Proposed Industrial Subdivision

Lot 4 in DP 635505, 150 Lismore Road, Bangalow

Response to TfNSW Letter to Council dated 25th January 2022

Fig 1 Maximum Feasible 2033 AM (PM) Peak Hour Traffic Volumes Based on Table 2 “Revised” Estimates

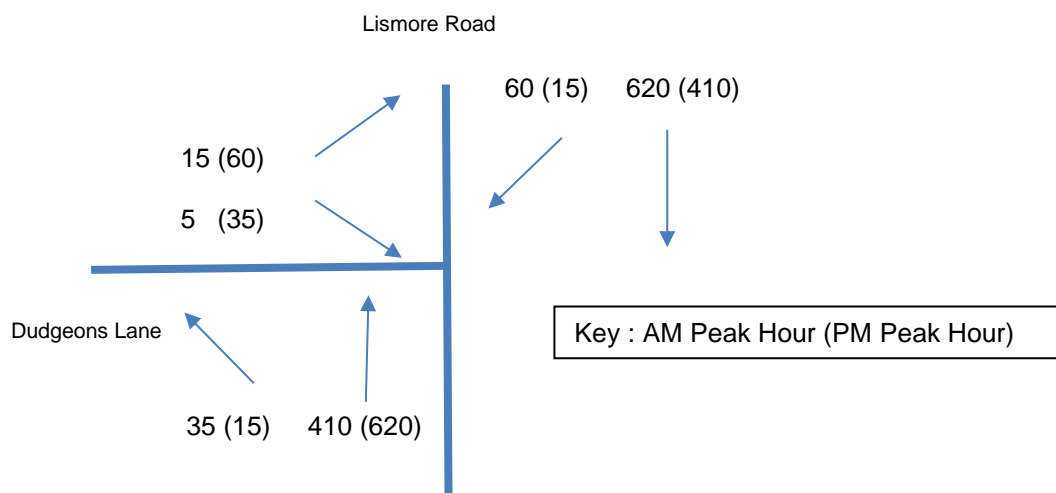
1. The supporting Traffic Engineering Assessment dated 20 May 2021 focuses on one potential use of the subject site and it is unclear if this reflects the highest-best use of the site under the proposed IN1 zoning. The TIA does not demonstrate vehicular access for relevant design vehicles. crossing. It is unclear if the supporting SIDRA analysis has been calibrated to reflect existing and forecast traffic conditions. The TIA should typically include 'Movement Summary' outputs for existing conditions, with development and without development along with digital files for review and validation.

The Traffic Engineering Assessment Addendum dated 29 October 2021 assumes that the subject site will be developed for service industry and low impact industrial categories, which may not reflect the range of permissible use in under the proposed zoning.

Notwithstanding, the assessments suggests there is sufficient capacity in the existing road network to support future uses of the subject site. Council should be satisfied that the Planning Proposal has demonstrated that existing infrastructure can support future uses of the subject land that are likely to be enabled by the proposed zoning.

TPS estimates contained in the 20th May report to which TfNSW refers were based on an “average” rate of 7.5 vph/100 sq.m.(gfa) in peak hours. In order to respond to the TfNSW request we have now revised the original traffic generation and 2033 intersection traffic estimates based on the top of the any range shown in the above table. That is, a traffic generation rate of 1.2, 1.5 and 12.0 vehs/100 sq.m.(gfa) for the AM, PM and Daily periods applied to 3,500 sq.m.(gfa) or 50% of site area.

Fig 1 shows estimated 2033 peak hour intersection volumes after adjusting for the revised traffic generation shown in Table 2.

Despite the peak hour traffic generation estimates on which the TPS 20/5/21 report was based having been increased by approximately 70%, the SIDRA estimates shown in Tables 3 and 4 do not indicate any significant change in 2033 peak hour intersection operations. That is, degrees of saturation remain at approximately 35%, average delays remain at approximately 2 seconds and 95th percentile queues for any movement are less than 6.5m.

The revised estimates show conclusively that even with the maximum feasible development in the subject site, the 2033 peak hour operation of the Lismore Rd / Dudgeons Lane intersection will be significantly less than capacity and all movements will operate with minimal queues and delays.
